SSC Service Bulletin

no. 83-307

MODELS AFFECTED: MCE 21/24 WITH REPEATER TALK-AROUND AND WITH
OPTIONS MA-130 TIME-OUT TIMER OR MA-163
AUDIO PA

CONNECTION OF MA-130 IN MCE 21/24 WITH MAIN BOARD
OPTION AND SIMPLEX CONVERSION (MA-359) ALSO
CONNECTED (REPEATER TALK-AROUND).

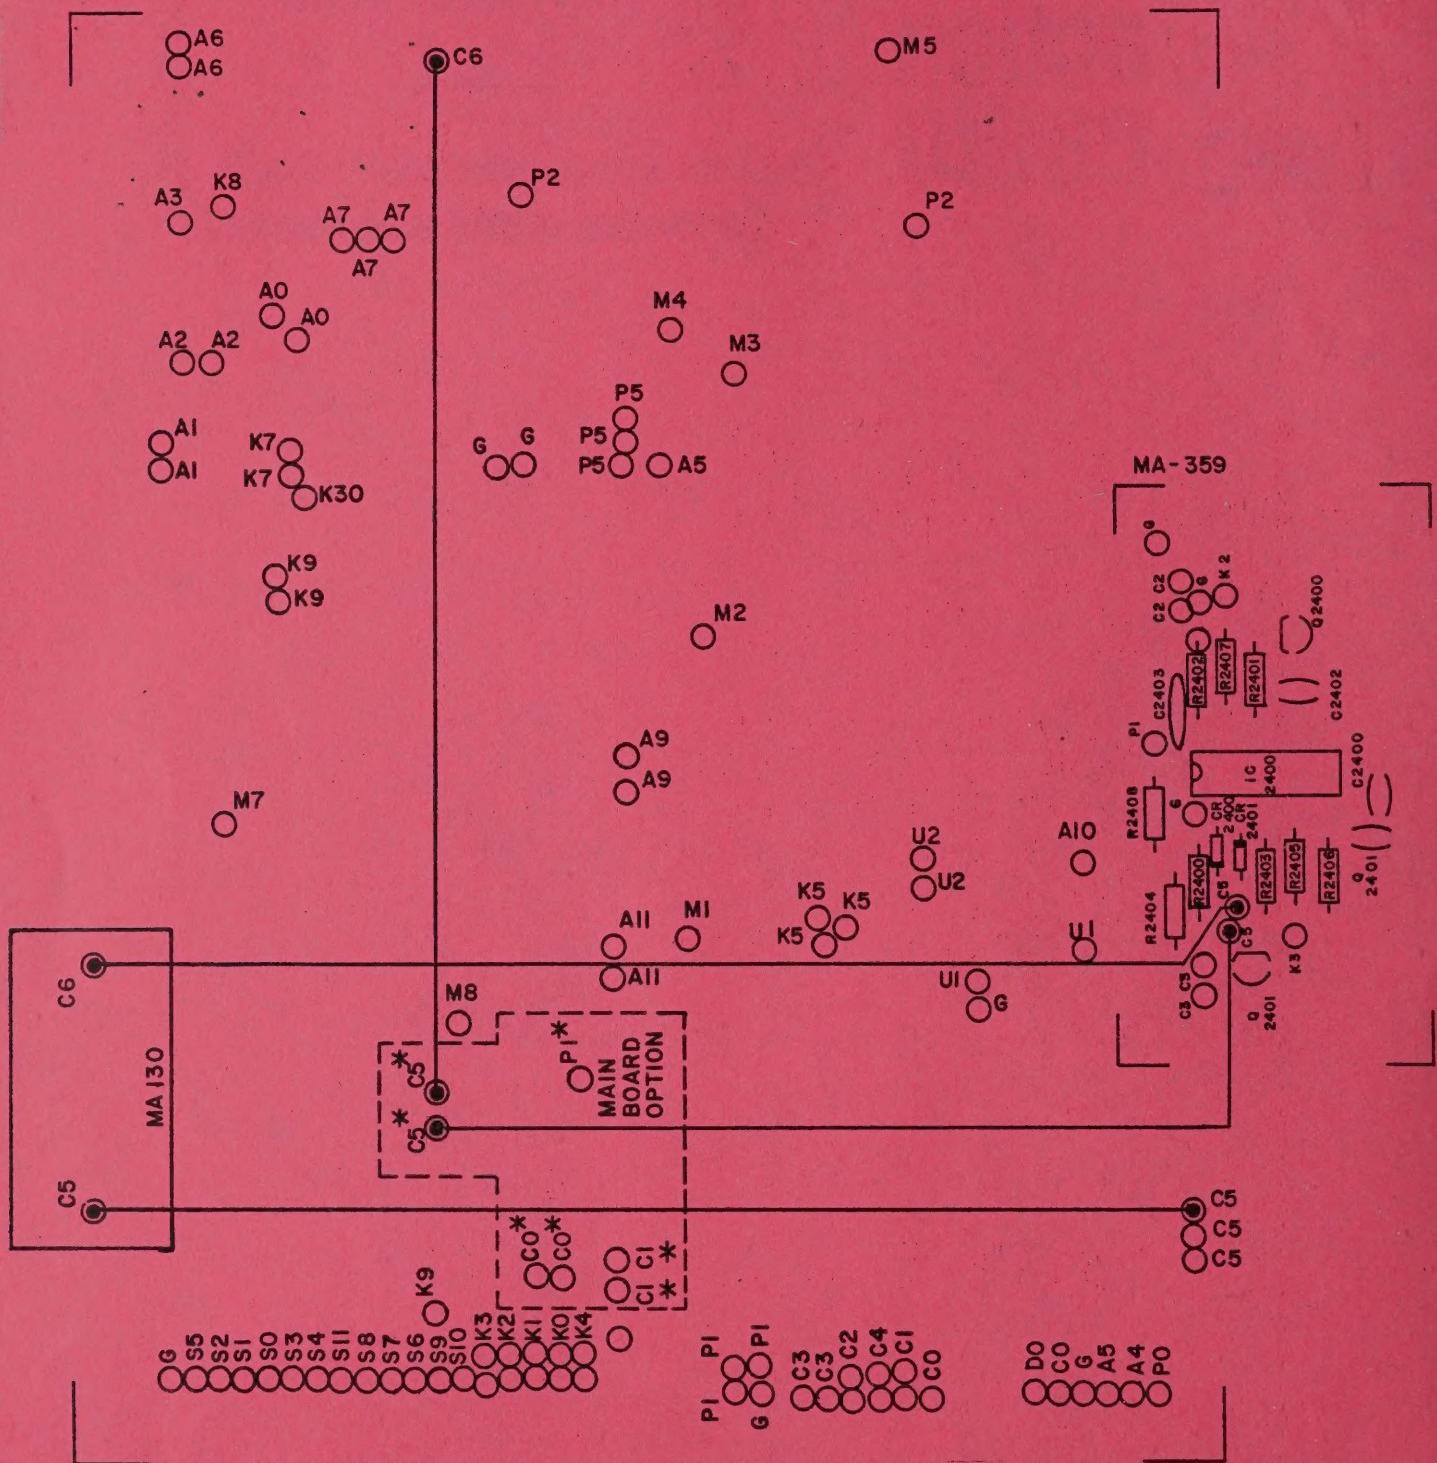
If the Main Board option is not connected (no repeater talk-around or simplex radio operation) the installation instructions given in the option service manual should be followed. The instructions for installing MA-130 or MA-163 (or any option requiring C6) in the MCE 21/24 change when the Main Board Option or the Simplex Conversion Option (MA-359) are also installed. Use the attached wiring diagram to connect the C6 and C5 pins on the Time-Out Timer Option. Keep in mind that the Main Board option pins are not the same as radio pins (unless the jumpers are connected) and that options are connected only to the radio. Install the remaining jumper wires as described in the appropriate option manual.

* THESE OPTION TIE POINTS ARE TO BE USED ONLY IN THE INSTALLATION OF THE MAIN BOARD SIMPLEX CONVERSION OPTION FOR THESE ARE CONNECTIONS FROM THE OPTION TO THE RADIO.
